From: Fosque, George <GFosque@Cambridge911.Org>
To: 'Angela McCanna' <amccanna@lymeproperties.com>
Cc: "Snow, Paula" <PSnow@Cambridge911.Org>, "Reardon, Gerry" <GReardon@CambridgeFire.Org>, "Owen Oriordan (E-mail)" <ooriordan@CI.Cambridge.MA.US>
Date: Friday, January 4, 2002 2:43 PM
Subject: RE: proposed street name and building numbers

Re: Kendall Square Project- Street Names & Building Addresses:

PROPOSED
STREET NAMES
&
BUILDING ADDRESSES

for:
The Kendall Square Project

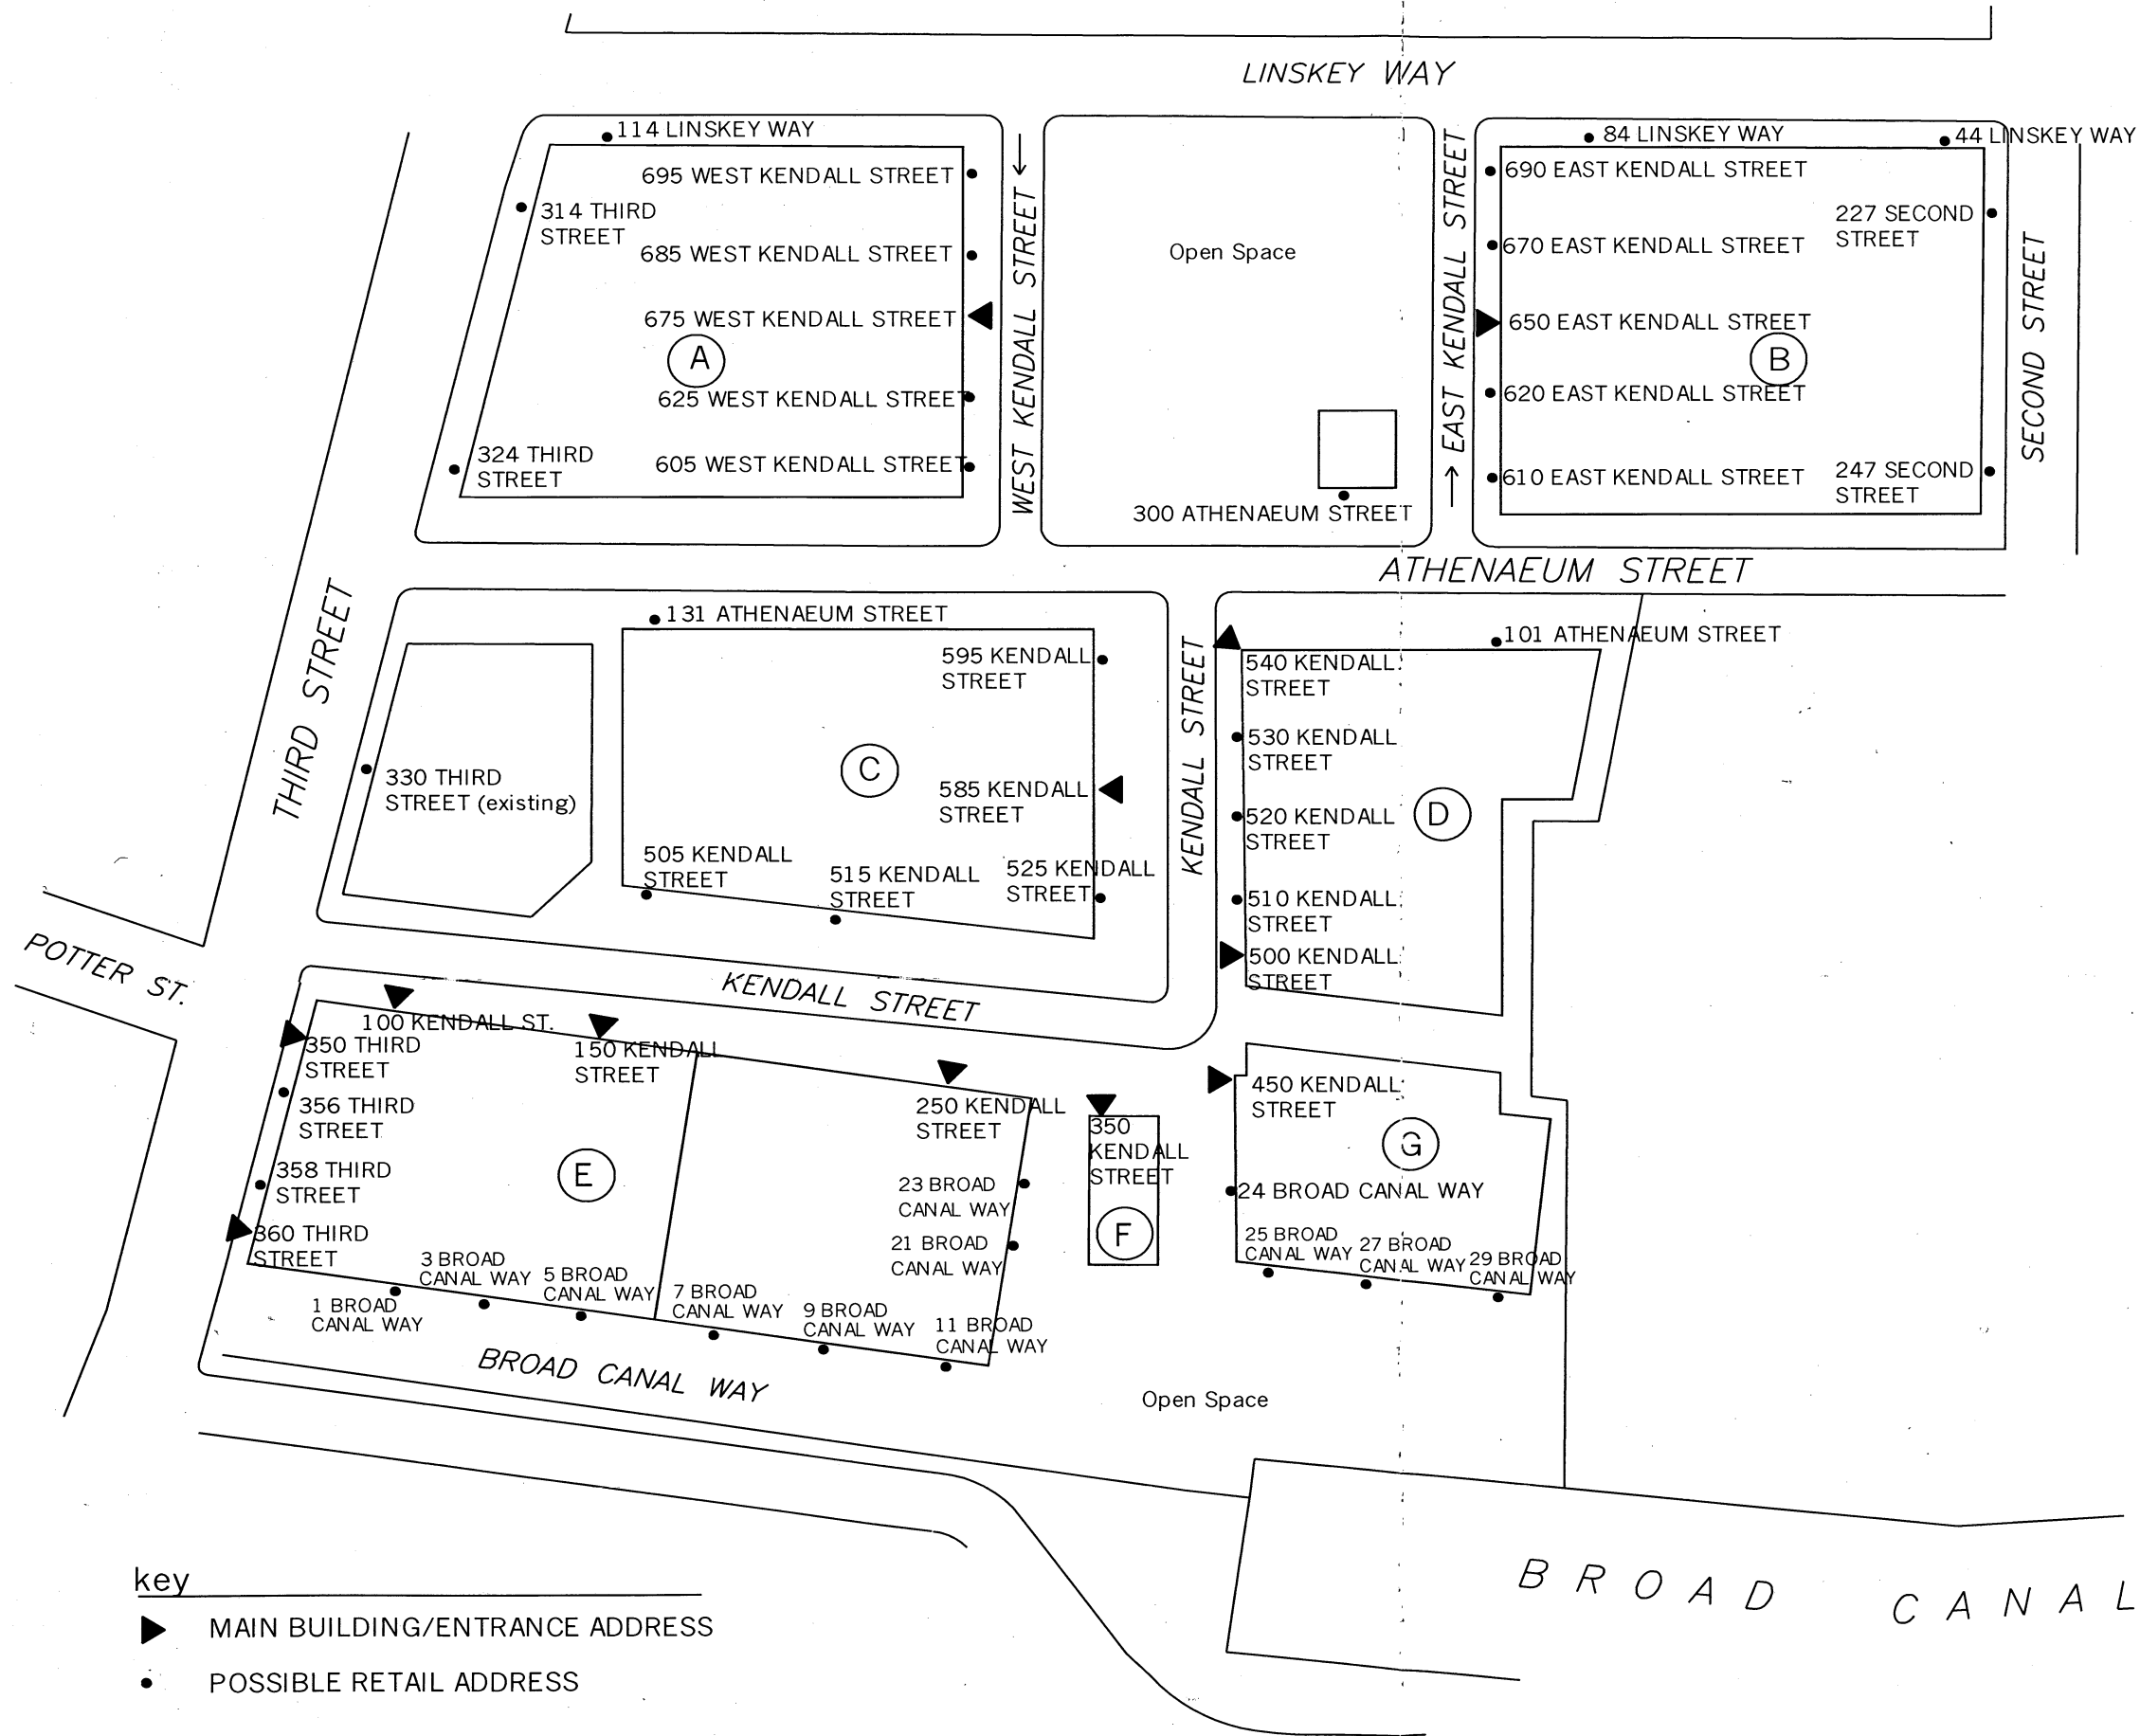
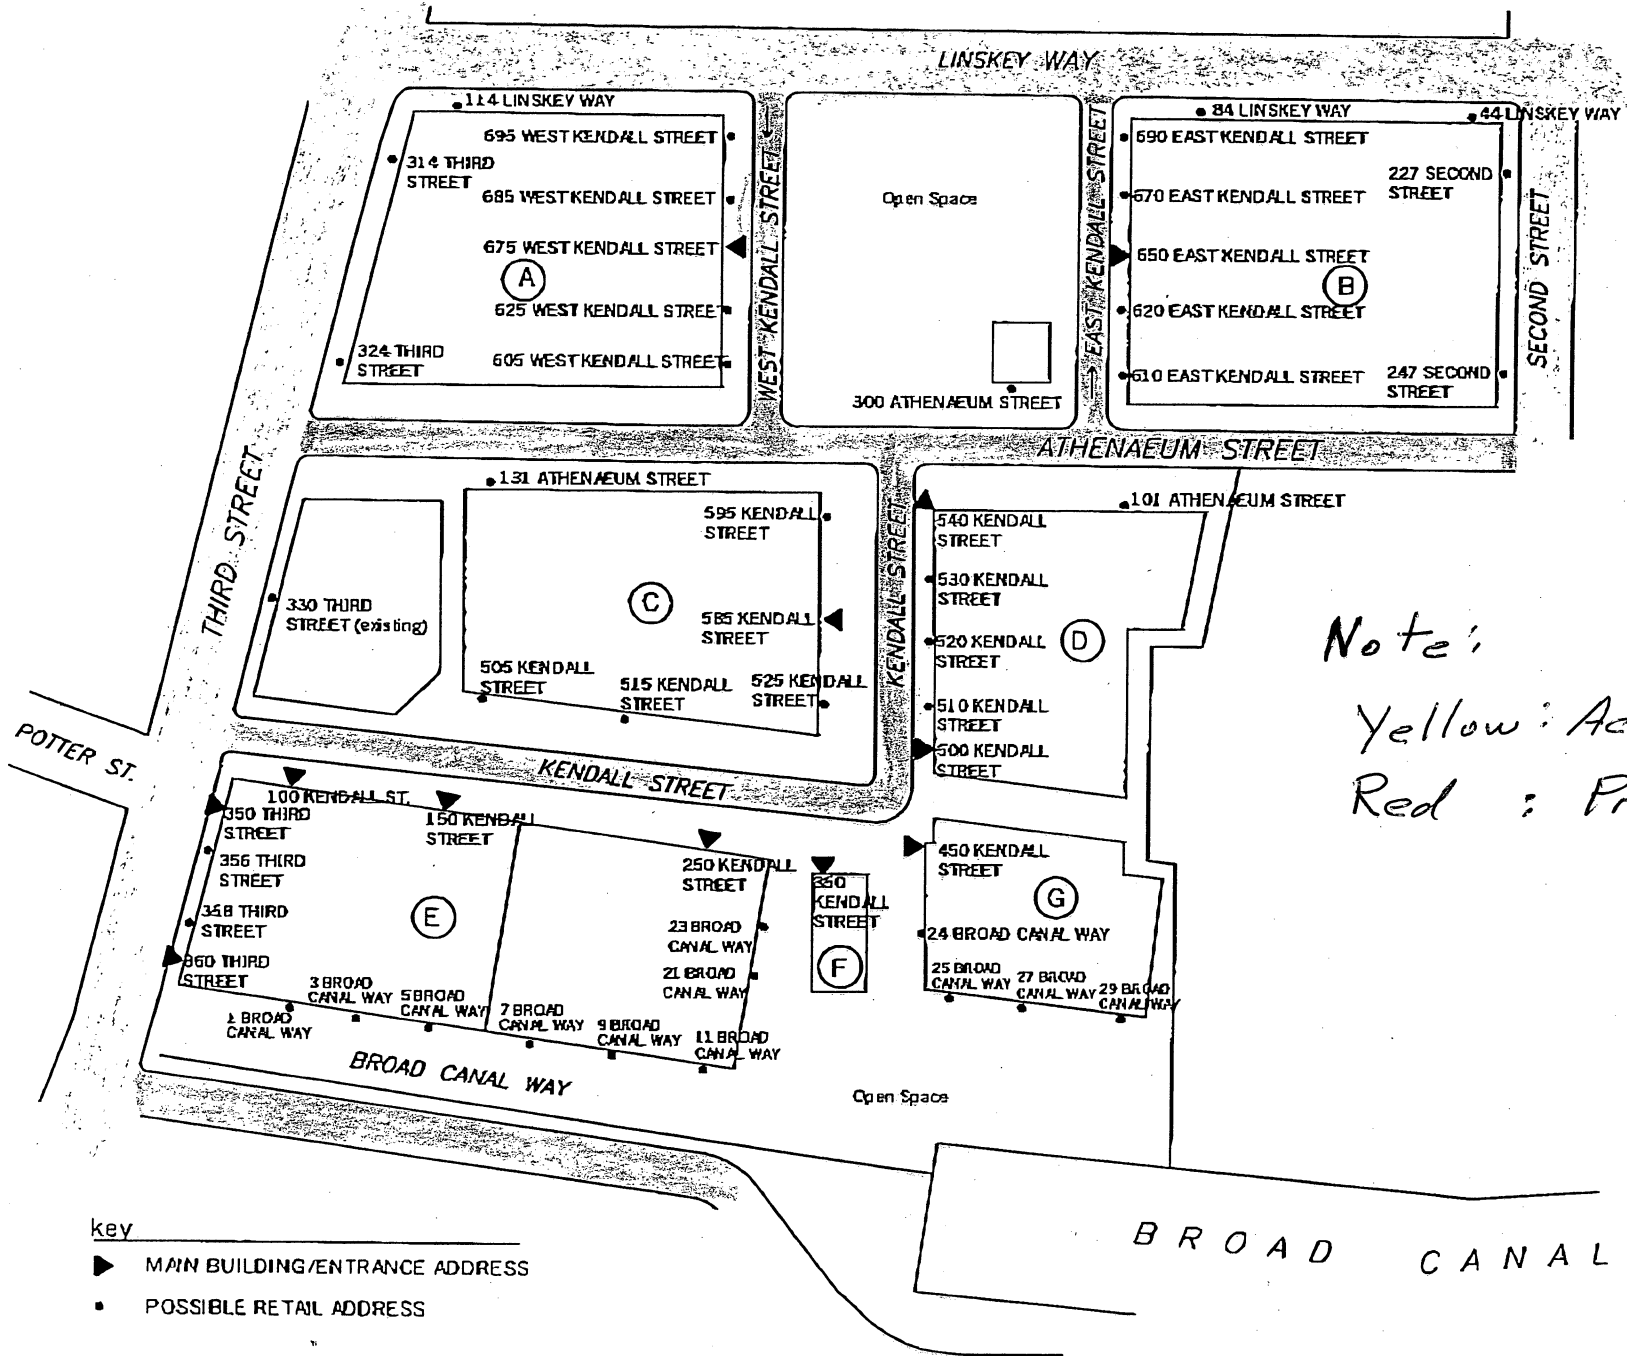
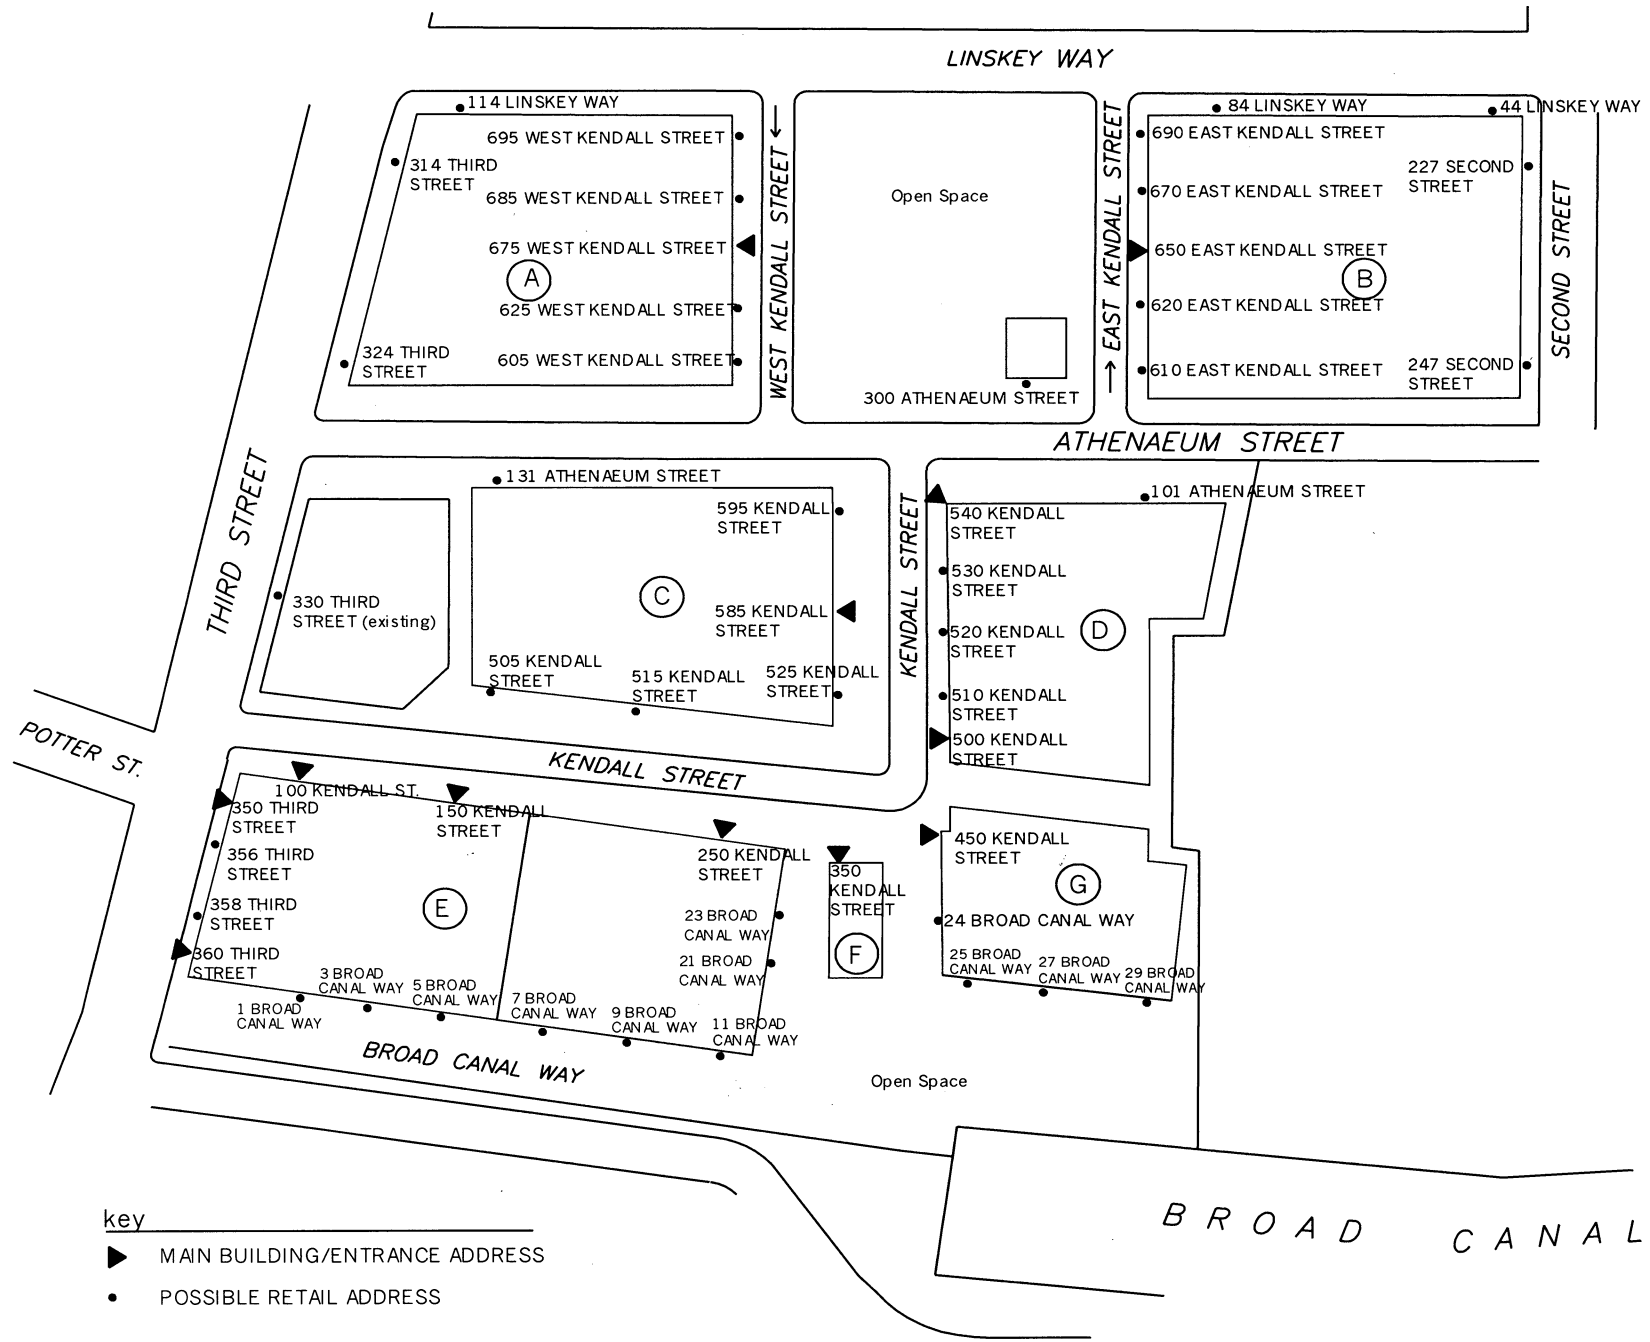
The Plan for street naming and building addresses have been reviewed by the City of Cambridge Engineering Department for any conflict having to do with duplication of street names or addresses. We have found no conflicts with our existing records. The new streets will be private ways within the City at this time. The portion of Athenaeum Street between Second Street and Third Street will be part of the Lyme Properties and unaccepted at this time.

If the naming of these streets are acceptable to the City Council, the Engineering Department will then inform all necessary agencies for address assignments. If there are any further questions please call me at 349-4845.
